GNRO-2016/00024

SUBJECT: Operating License Manual Update Submittal
Grand Gulf Nuclear Station, Unit 1
Docket No. 50-416
License No. NPF-29

Pursuant to 10 CFR 50.71(e), Entergy Operations Inc. hereby submits an update of all changes made to the Grand Gulf Nuclear Station Operating License Manual (Technical Specification Bases, Technical Requirement Manual, and Offsite Dose Calculation Manual, since the last submittals (References 1 and 2 above). The Pressure Temperature Limits Report) was last submitted under Reference 3 as a proprietary document and is being resubmitted in accordance with the requirements of 10 CFR 50.71(e).

1. Change Summary
2. Technical Specification Bases Changes
3. Technical Requirements Manual Changes
4. Offsite Dose Calculation Manual Changes
5. Pressure Temperature Limit Report Changes
6. GEH Affidavit

Figure 3.0-1
Collection Site Locations, 0-4 Mile Area Map

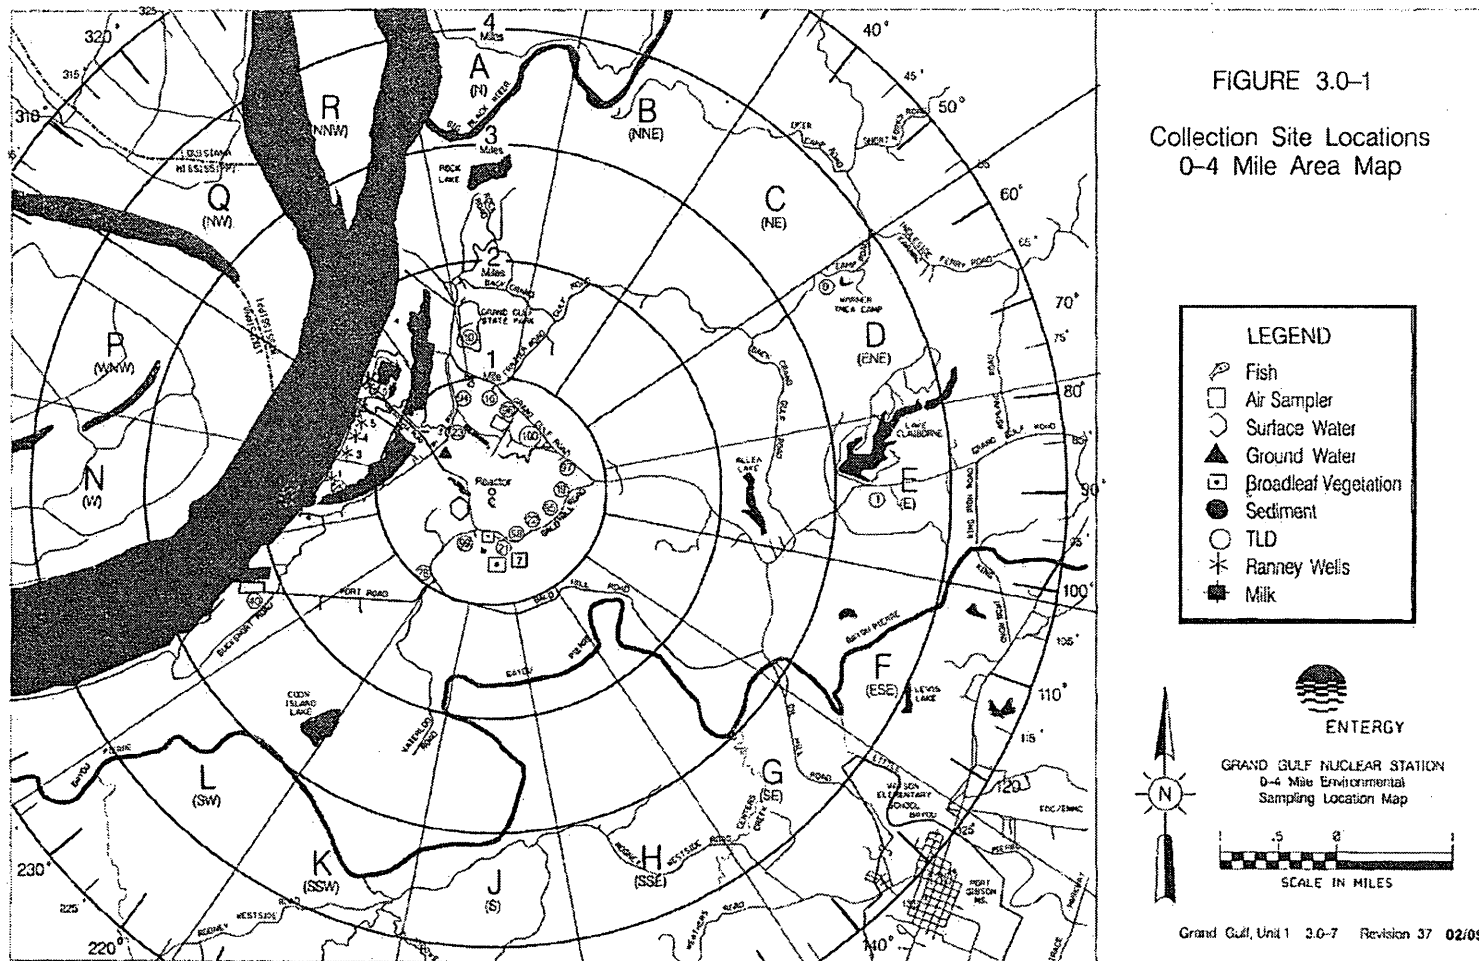
LBD CR Number	Topic of Change	Affected Technical Specification Bases Pages
2011-0002	Placement of Radial Well into Service	ODCM Figure 3.0-1
2011-0026	EPU Main Steam Line High Flow Isolation Setpoint Change	TRM Page 3.3-58 – II
2013-0009	Fire Protection TRM requirements updated for 24 month fuel cycle	TRM Pages 6.2-2, 6.2-23, 6.2-25, 6.2-27, and 6.2-34
2013-0024	Addition of ODCM 6.3.9 Condition E and applicable C and Change Condition D to be only applicable to Condition B	ODCM Page A-14
2014-0026	Technical Specification Bases and UFSAR update to remove Division I and II high vibration trips and alarms	TS Bases Pages B3.8-25,
2014-0027	First Stage Turbine Pressure Instrument Sensing Line Failure Multiple Times Requiring Temporary Modification	TRM Pages 3.3-8 – II, 3.3-18 – II, and 3.3-28 – I TS Bases Pages B3.3-15, B3.3-17, B3.3-28, B3.3-40, B3.3-41, B3.3-46, B3.3-68, B3.3-69a, B3.3-70, and B3.3-71
